# Staff Report

To: Salt Lake City Planning Commission  
From: Casey Stewart; 801-535-6260  
Date: April 21, 2016  
Re: PLNPCM2016-00118 Conditional Building and Site Design for AC Marriot Hotel and PEG Apartments

## CONDITIONAL BUILDING AND SITE DESIGN REVIEW

Civil Site Plan  
C.1.1

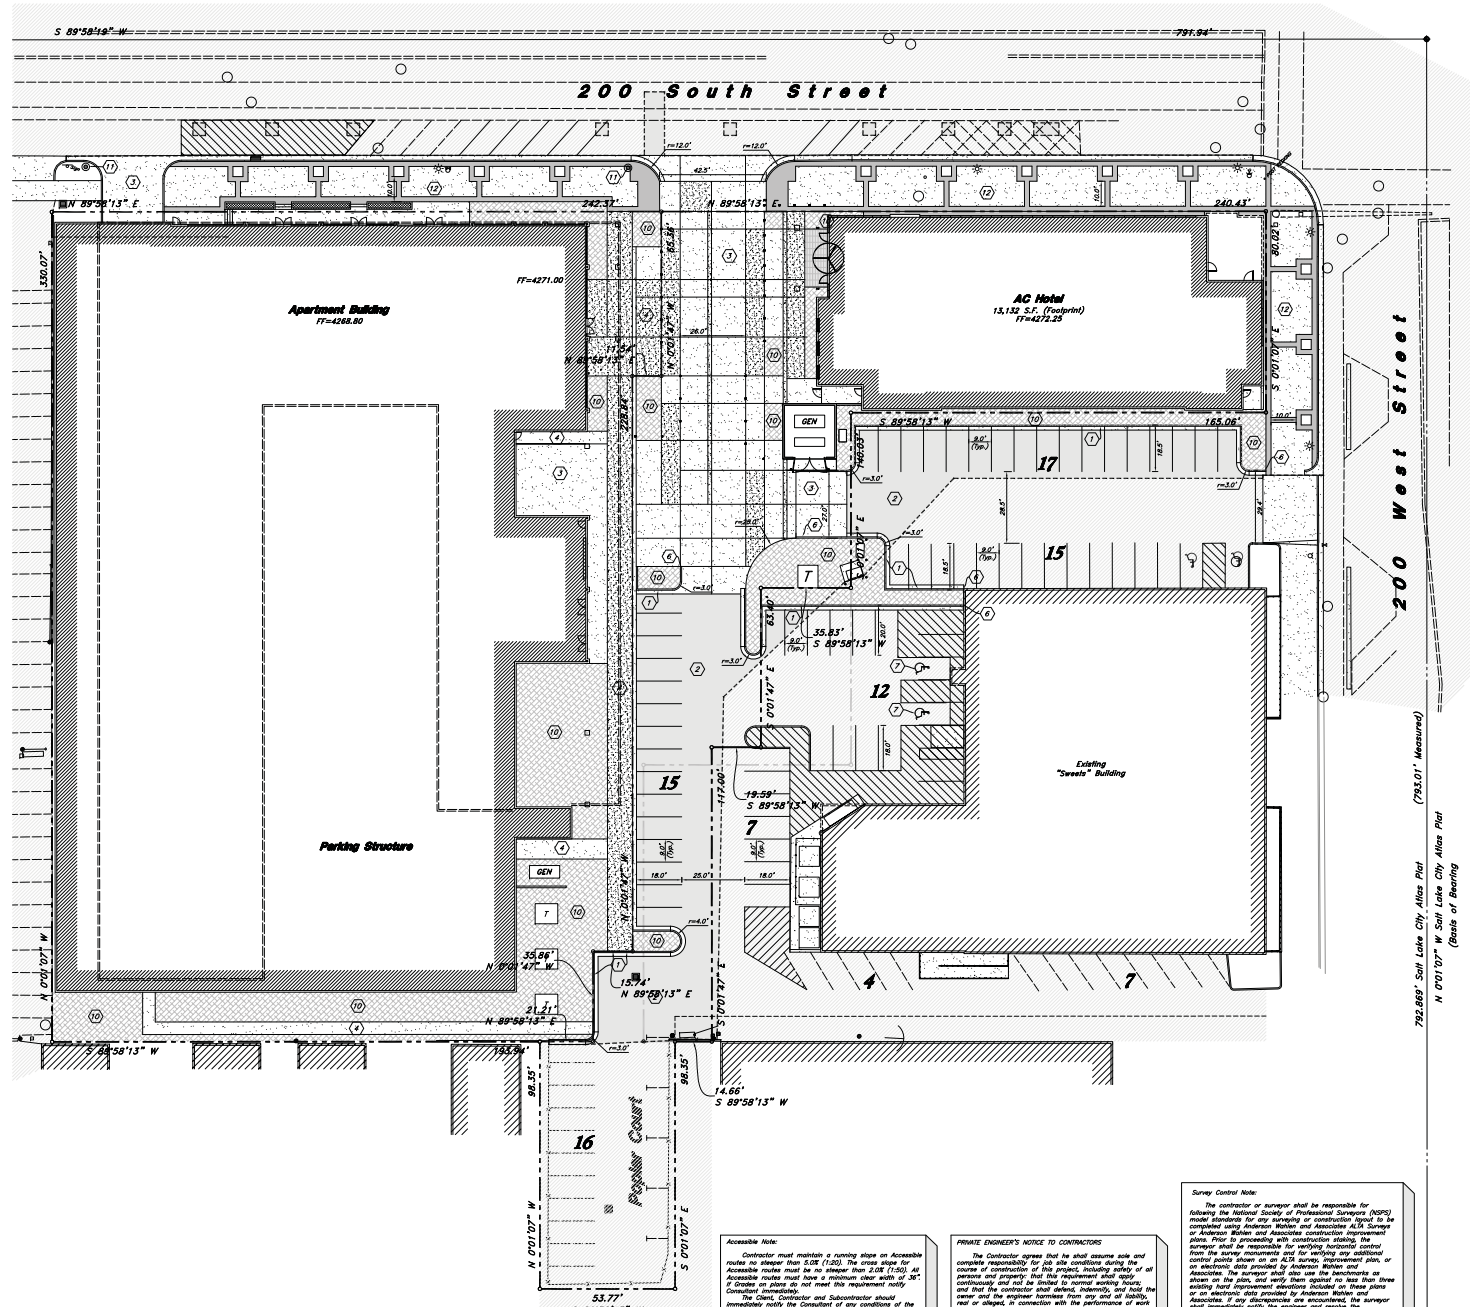
**Transportation** (Mike Barry): The project must comply with parking regulations per city code 21A.44. Shared parking must comply with city code 21A.44.040.B.1. The width of the driveway on 200 S (see sheet C1.1 Site Plan), shown on plan as 42.5 feet, exceeds the maximum driveway width of 30 feet per 21A.44.020.F.7.b.

(A1) NORTH ELEVATION  
SCALE: 1/8" = 1'-0"

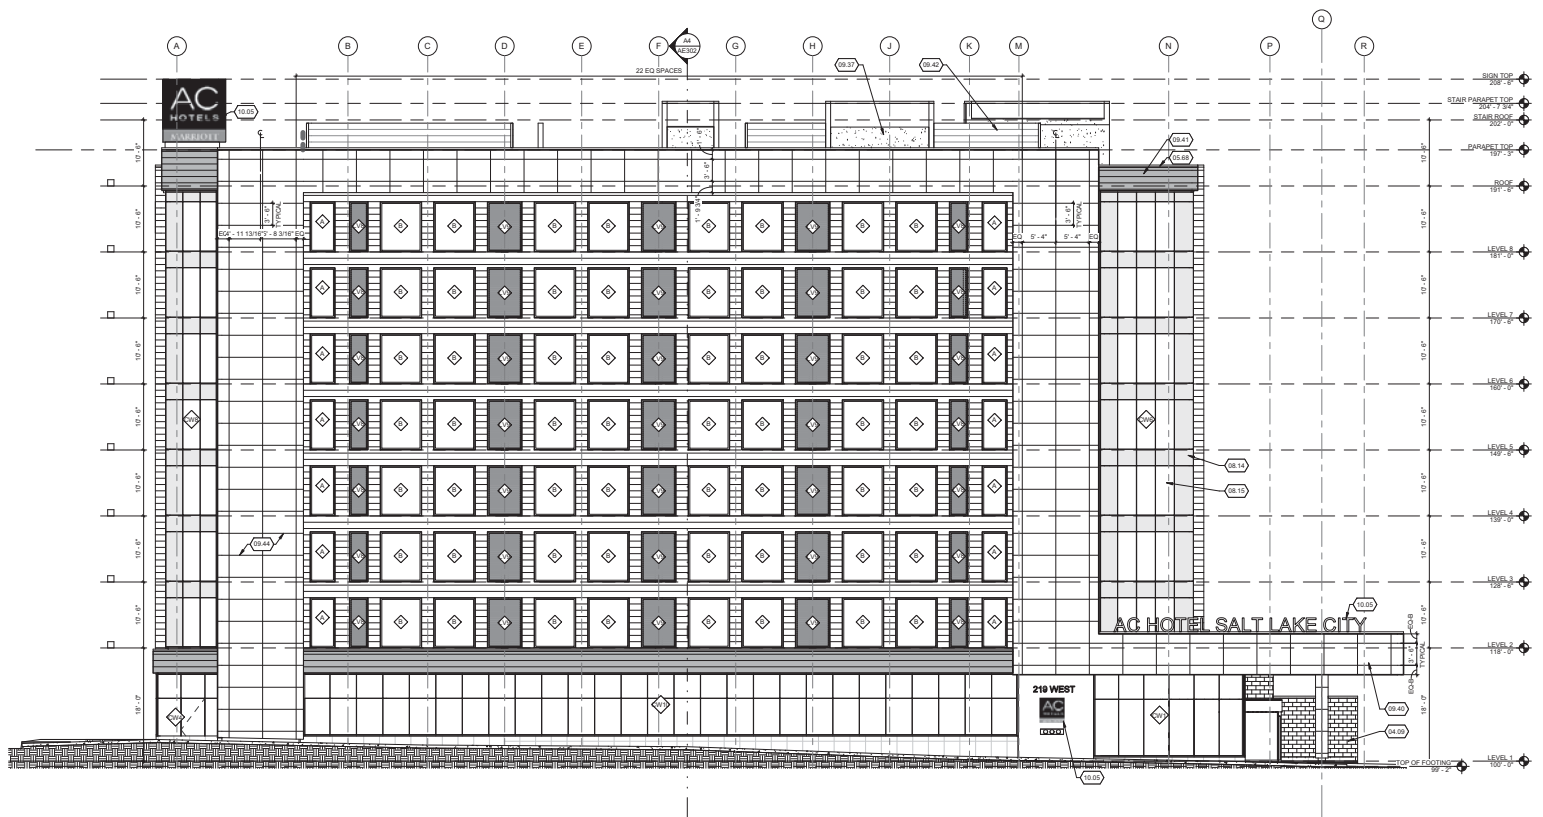
It is staff’s opinion that the flat roof line of the proposed hotel meets the standard for granting extra building height. A distinct roofline or a roof top amenity (garden, common space, renewable energy system, etc.) is a criterion when seeking extra building height. In addition, the hotel is proposed for a corner location, giving it a prominent visual location. However, in terms of downtown building height, 109 feet as proposed is comparatively shorter and likely will not directly affect the skyline of the city. The proposal does not include any of the named roof top amenities but the roof includes a few design aspects that achieve the desired result of being distinct: the roof top sign at the northeast corner of the roof (not the wall mounted sign on the north façade as shown in the color renderings), the white band across the top of the north façade that extends outward from the primary façade and continues down the corners of the north façade, and the offset façade planes at the top that help the white band stand out.
